ENGINEERING CHANGE NOTIFICATION

Brief description of the functional changes proposed:
This ECN describes changes necessary for support of integrated PCI Express devices in PCI Express Root Complexes. This ECN does not impact any existing functionality or devices.
Specification(s) this proposed change is against:
PCI Express Base Specification 1.0a
Benefits as a result of the proposed changes:
PCI Express devices can be integrated in root complexes for high integration systems. This capability is already supported by PCI devices today.
An assessment of the impact to the existing revision and systems that currently conform to the PCI specification:
No impact to systems or peripherals that conform to PCI Express 1.0a specification.
An analysis of the hardware implications:
Allows PCI Express devices to be integrated in root complexes; hardware supporting such devices will have to implement appropriate configuration space changes.
An analysis of the software implications:

Figure 0-1 Root Complex Event Collector Endpoint Association Capability

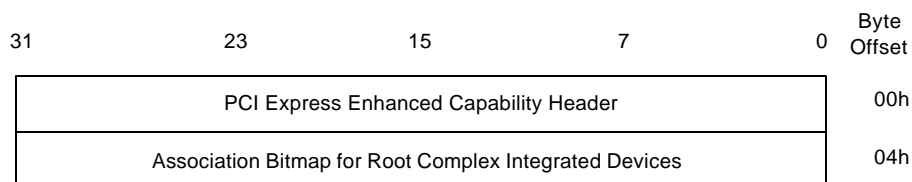
The PCI Express Root Complex Event Collector Endpoint Association Capability, as shown in **Error! Reference source not found.**, consists of the PCI Express Enhanced Capability Header followed by a DWORD bitmap enumerating Root Complex Integrated Endpoints associated with the Root Complex Event Collector.
